District Response to the Crystal River/Kings Bay MFLs Peer Review

February 21, 2017

CRYSTAL RIVER/KINGS BAY
MINIMUM FLOW AND LEVEL
PEER REVIEW

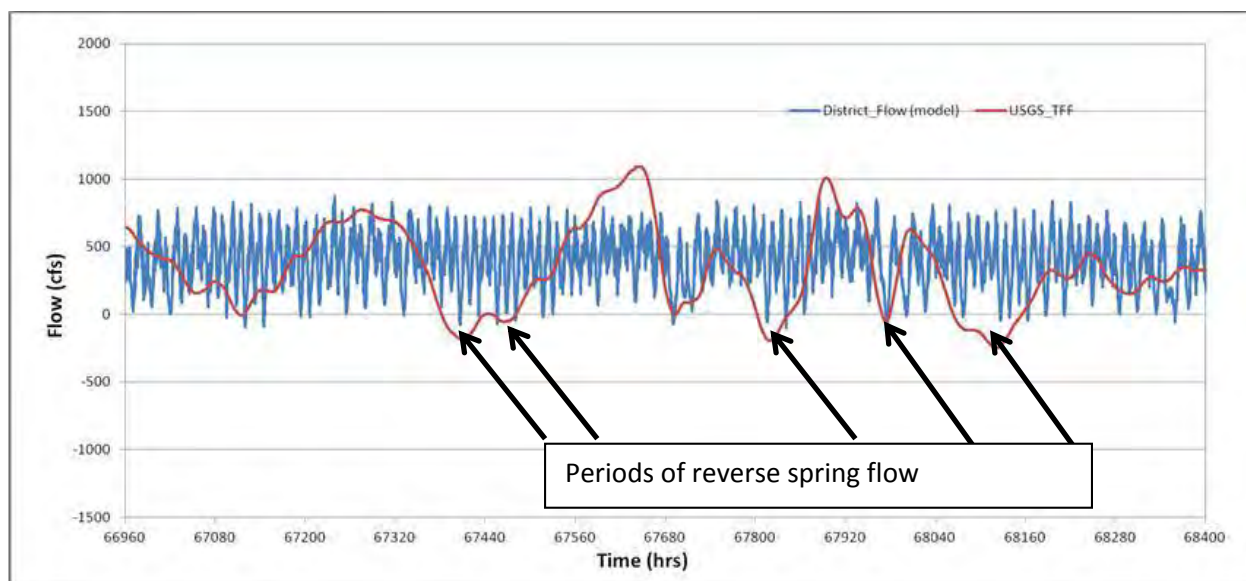
One, I’m concerned about the calculation of negative flow into the springs without convincing field evidence to support this hydrologic condition. The field data presented in this report do not support your hypothetical model results presented at our July 25, 2014 of reverse (negative) flow into the springs. Table 1 of the technical memo (see below) contain no negative values for measured spring flow indicating that negative spring flows were not observed during the data collection period from July 28 through October 8, 2009. However, figure 15 found in this report and enclosed with this memo, shows that negative discharges occur about 10 percent of the 60-day record (August 22, 2007 to October 20, 2007). My concerns regarding spring flow reversals were dismissed in the response memo stating “spring flow can be temporary negative and data indicating this phenomenon occurs in Kings Bay are available” but no data or real ground-water system analysis of this phenomenon is presented.
